CITY OF KELOWNA

MEMORANDUM

Date: September 15, 2020
File No.: Z20-0081
To: Urban Planning Management (KB)
From: Development Engineering Manager (JK)
Subject: 605 Gerstmar Rd RU1 to RU2

**SKETCH PLAN OF PROPOSED SUBDIVISION OF LOT 5
 SECTION 22 TOWNSHIP 26 OSOYOOS DIVISION YALE DISTRICT PLAN 19913**

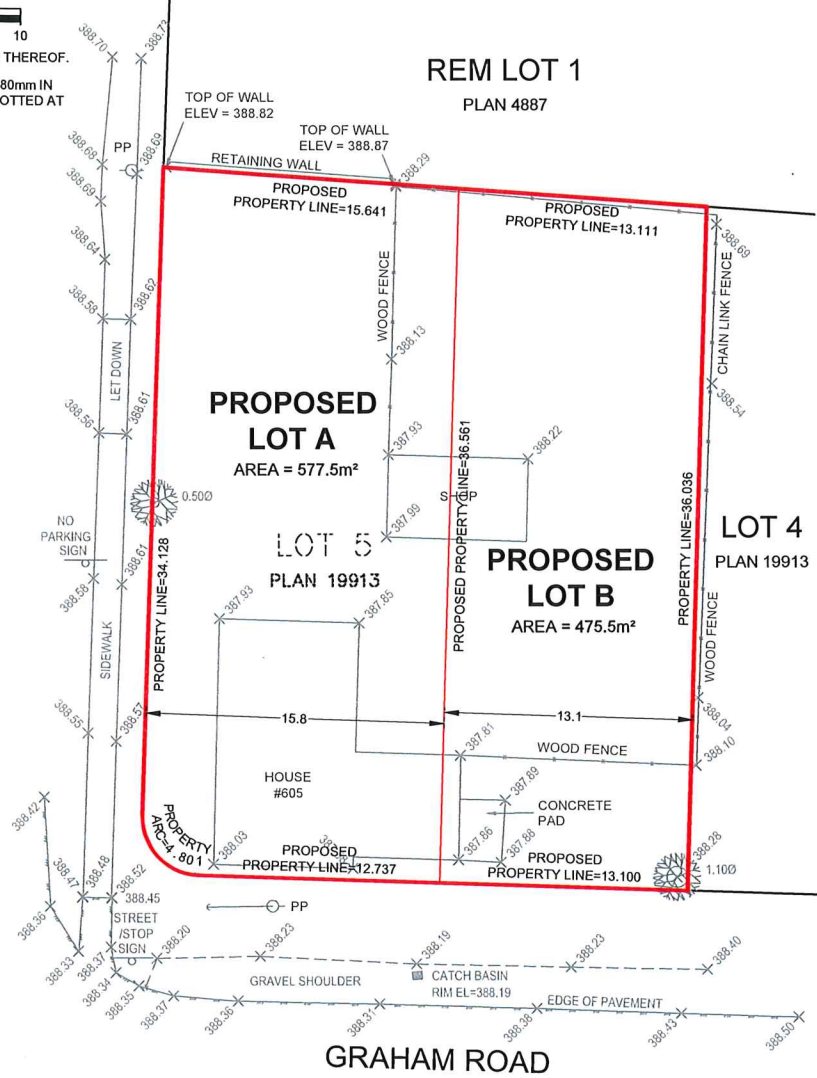
- a) Each legal lot shall require only one individual sanitary service connection complete with an inspection chamber (SS-S7) and Brooks Box (SS-S9), to be installed at the applicant's cost.
- b) The existing lot is currently serviced with a 100-mm sanitary service. If the existing service connection is to remain it will be required to be completed with an inspection chamber and Brooks box.

- a) Gerstmar Rd is classified as a Major Collector under the City of Kelowna's 20-Year Major Road Network. The section of Gerstmar Rd must be upgraded to a collector standard along the full frontage of this proposed development, including sidewalk, curb and gutter, pavement removal and replacement, boulevard landscaping, drainage infrastructure (catch basins, perforated storm pipe, and drywell), and re-location or adjustment of utility appurtenances if required to accommodate the upgrading construction. The road cross section to be used is SS-R6.
NOTE: Pipe and drywell inverts to consider eventual connection to existing storm main at Gerstmar Rd and Tataryn Rd – DWG A-2482-4.

- c) Graham Rd must be upgraded to a local standard along the full frontage of this proposed development including curb and gutter, pavement removal and replacement, boulevard landscaping and re-location or adjustment of utility appurtenances if required to accommodate the upgrading construction. The existing catch basin is to be relocated to the new gutter line. The road cross section to be used is a modified SS-R3.
